TRANS/WP.29/2001/43

World Forum for Harmonization of Vehicle Regulations (WP.29)

PROPOSAL FOR DRAFT SUPPLEMENT 6 TO THE 02 SERIES
OF AMENDMENTS TO REGULATION No. 7

(Position, stop, and end-outline marker lamps)

"1. Front position (side) lamp

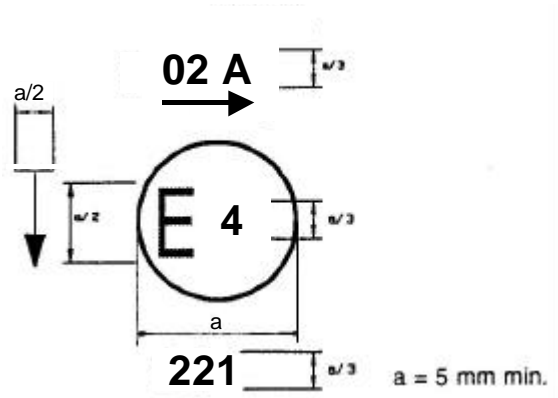
Annex 3,

The example of the approval mark, amend to read:

Caption below Figure 1, second sentence, amend to read:

".... 02 series of amendments. The horizontal arrow indicates angle of 80° H. The vertical arrow starting from a horizontal segment and directed downwards indicates a permissible mounting height of equal to or less than 750 mm from the ground for this device."
